**Proposed Temporary Open Storage of Construction Material and Machinery
for a Period of 3 Years and Associated Filling of Land in “Agriculture” Zone,
Lots 357 (Part) and 359 (Part) in D.D. 87, Hung Lung Hang
(Compliance with Approval Condition (a) for Planning Application No. A/NE-FTA/246)**

Compliance with Planning Condition (a)

(S.16 Planning Application No. A/NE-FTA/246)

Drainage Proposal

REV	DESCRIPTION	DATE
DRAWING TITLE PROPOSED DRAINAGE SYSTEM		
DRAWING NUMBER FIGURE 3

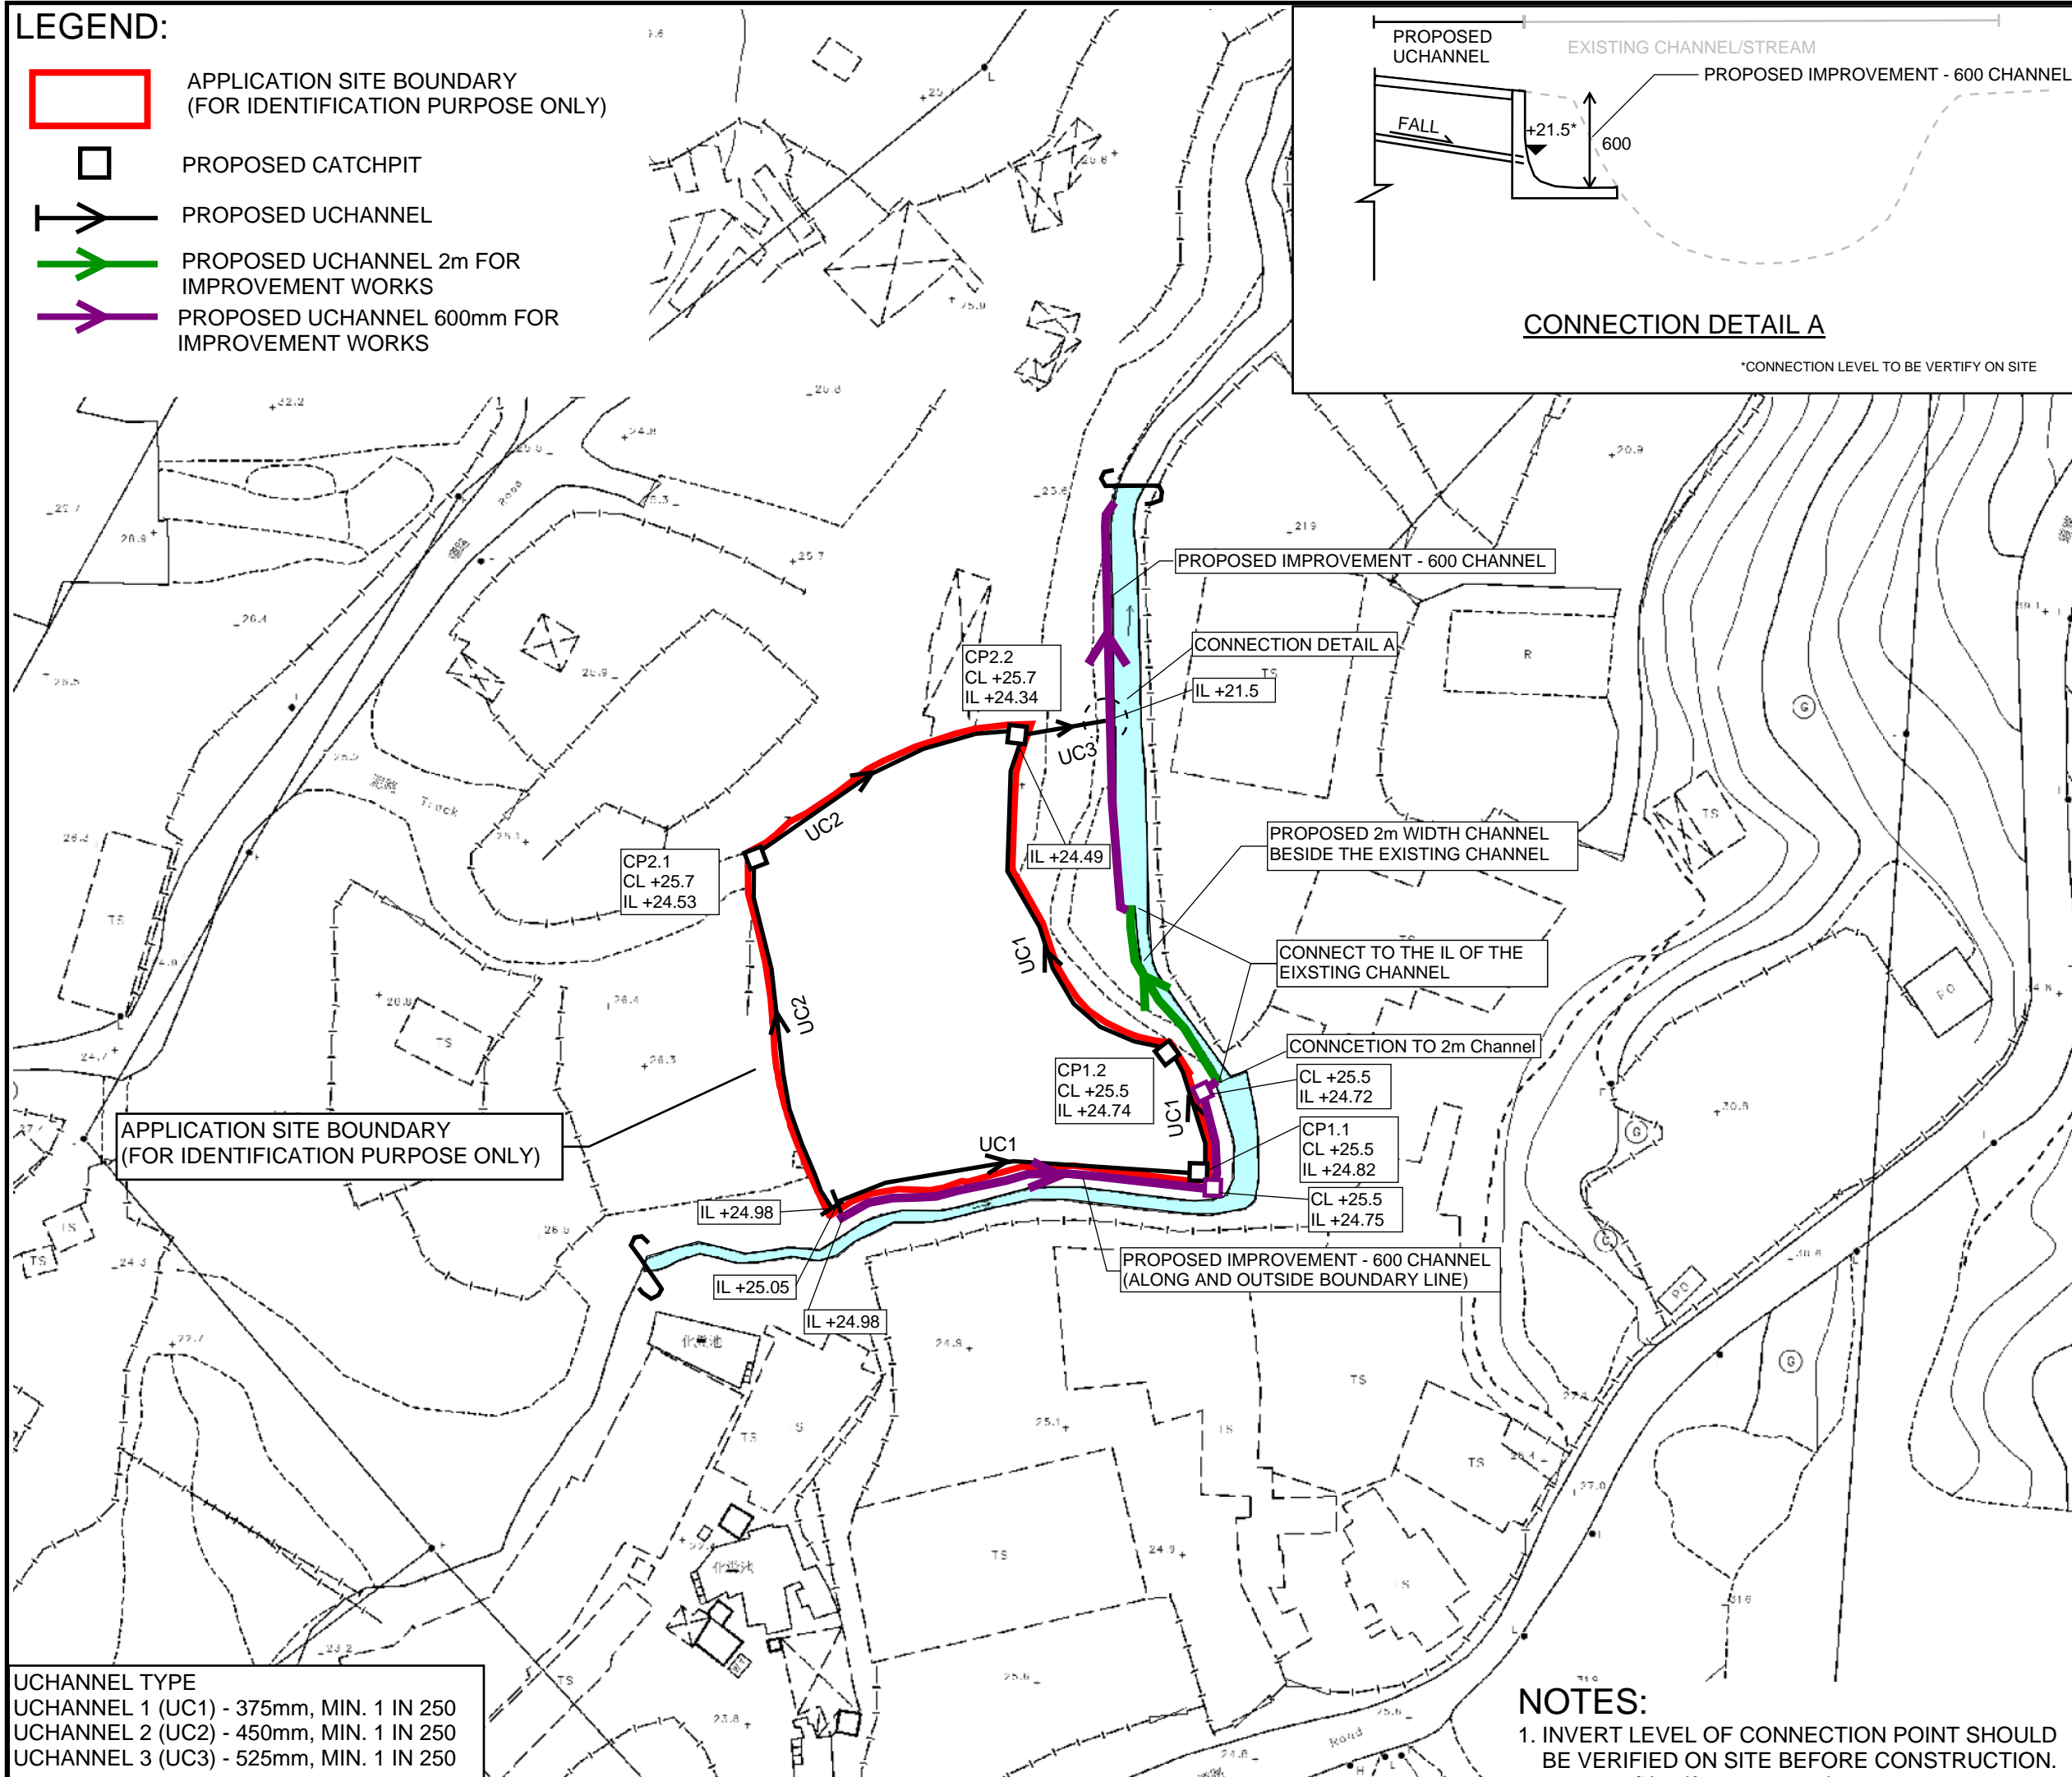
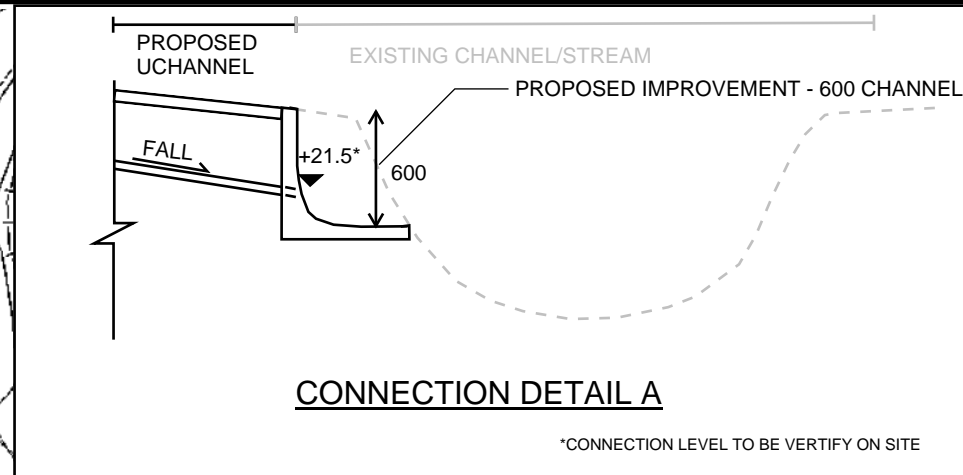
Departmental Comments		Applicant’s Responses
Comments of Chief Engineer/Mainland North, Drainage Services Department (CE/MN, DSD) (Contact Person: Mr. Samuel WANG; Tel.: 2300 1135)		
1.	The connection pipe from the 600 mm U-channel to the 2 m open channel was at height and the rain water would be free-falling to the channel. Please extend the connection pipe at the direction to the downstream open channel as appropriate. Also, please ensure the discharged water would fall to the downstream open channel rather than the upstream natural watercourse.	The applicant has extended the connection pipe at the direction to the downstream open channel. Please refer to the enclosed site photos.
2.	The construction of catch-pit covers was not completed in the Site, please follow up.	Catch-pit cover has been installed. Please refer to the enclosed site photos.
